**FINAL DECISION DOCUMENTATION**  
for  
**Timber Sales within the Revised Westside Project**  
**Environmental Assessment (EA OR118-05-021)**

**United States Department of the Interior**  
**Bureau of Land Management**  
**Glendale Resource Area, Medford District**

### **Public Comment to Revised Westside Project Environmental Assessment and BLM Response**

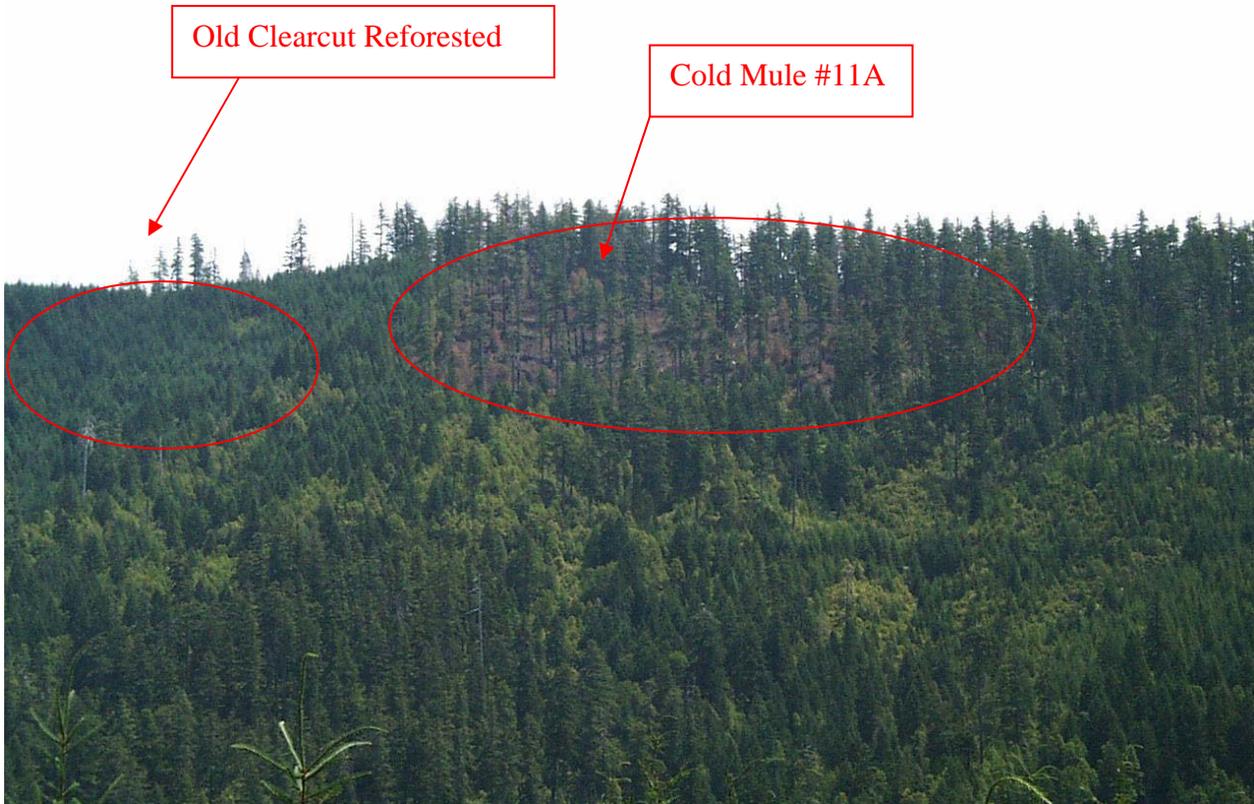
*Comment 1: A number of letters from the public oppose old growth logging and interchange the word "clearcutting" for regeneration harvesting.*

**BLM Response:** Comments that a regeneration harvest is merely a clear cut is unfounded. The definition of clearcut harvest, as defined in the Medford District *Resource Management Plan*

The photo below is taken of Unit #3 of the Lost Fortune Timber Sale, in the foreground, that is within the Westside Project Planning Area. Approximately 10 large trees per acre were retained in this overstory removal.

Below is a photograph of Cold Mule unit #11A, which was treated with a regeneration harvest in 2000. Unit #11A is located in the center of the photo and retains approximately 7-9 trees per acre (1-2 additional trees are retained for coarse woody debris and future snags) as required by the Medford Resource Management Plan. In comparison the young stand to the left is an old “clearcut” harvest from the 1960’s now reforested with conifers.
